**Northeast  
Utilities System**

**Re: *Petition No. 906. Amendment Letter for the 345-kV Middletown Rebuild Project***

Attachment A: Drawing No. 22823 Scovill Rock Substation

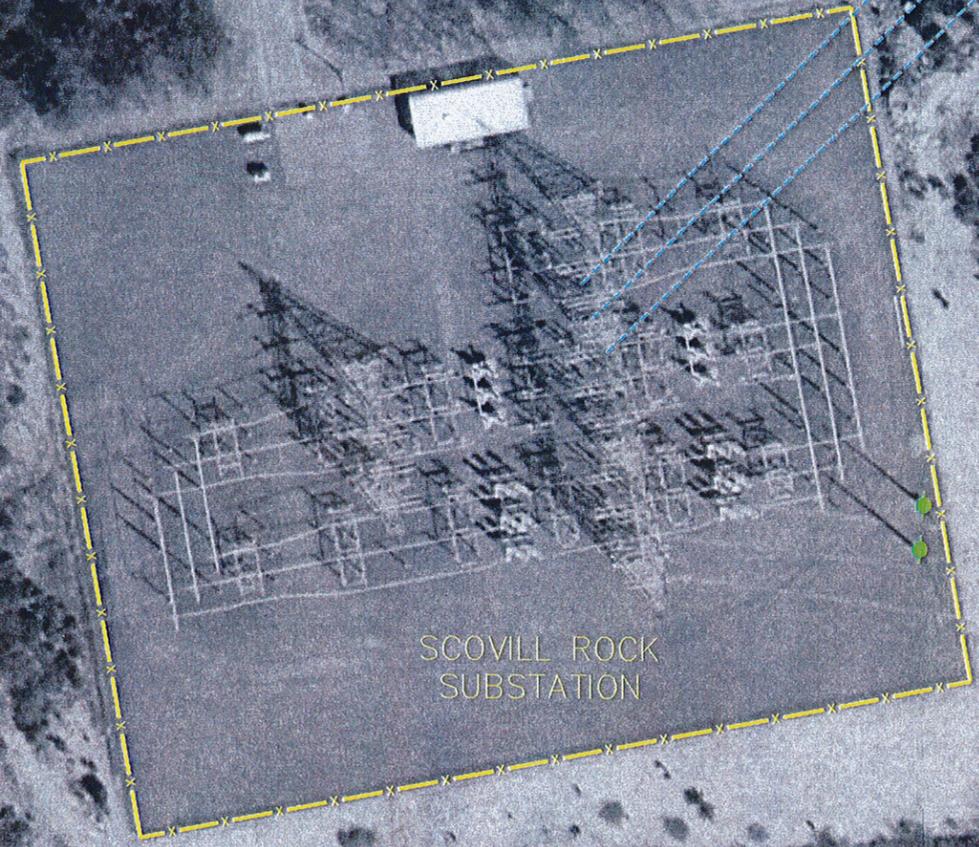
- Reconductor the approximately 350 foot span from the Scovill Rock Substation to the first structure (#12069) on the 3533 line outside of the substation from a single 2156 ACSR per phase to a bundle of (2) 954 ACSR per phase. (see Attachment A: Drawing 22823)
